**RE: Lot 9 Block 1 Volcano Cliffs Unit 22 SAD 228
8005 Alto Rey Ct. NW
Grading and Drainage Plan
Engineers Stamp Date: 10/19/2020 (D10D003N9)
CO Certification Date: 3/11/2021**

Based upon the information provided in your submittal received 3/22/2021, this plan cannot be approved for Building Permit until the following comments are addressed.

SHEET TITLE:
GRADING AND
DRAINAGE PLAN

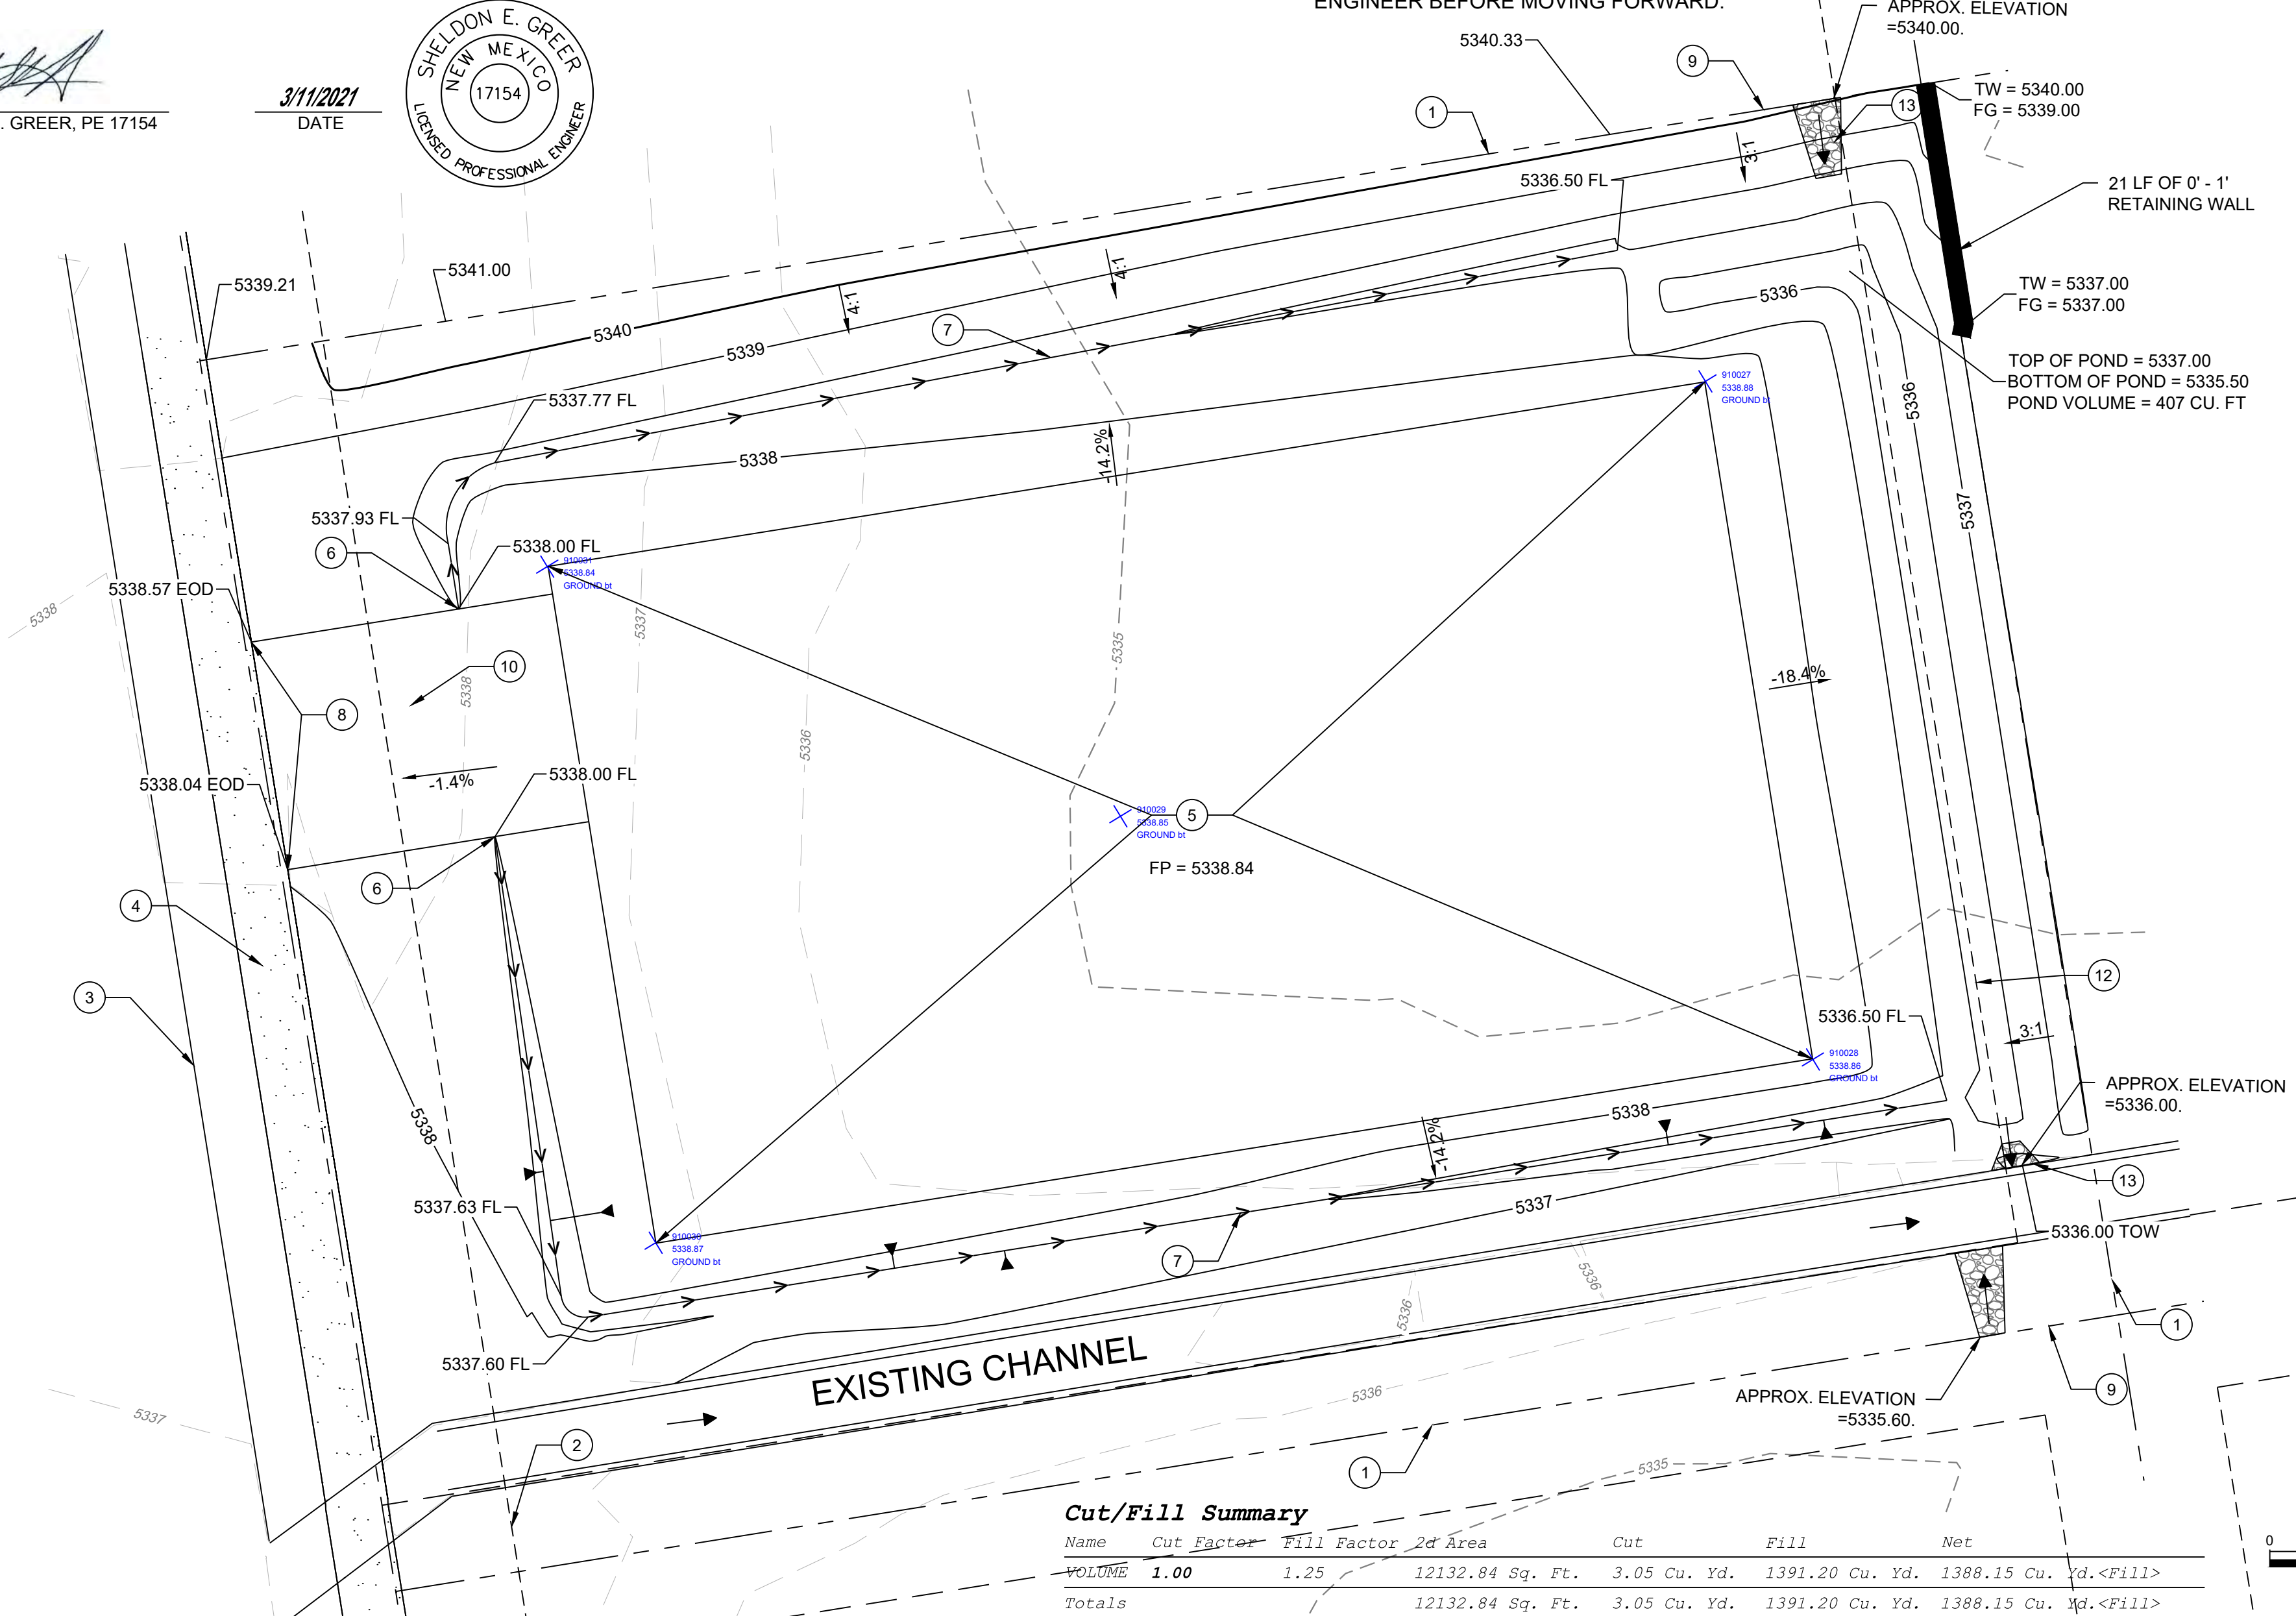
- Lot did not have an address, provide address
- Have all dirt ramps removed from the streets. Crusher fines or lumber are to be used for driving over a curb.
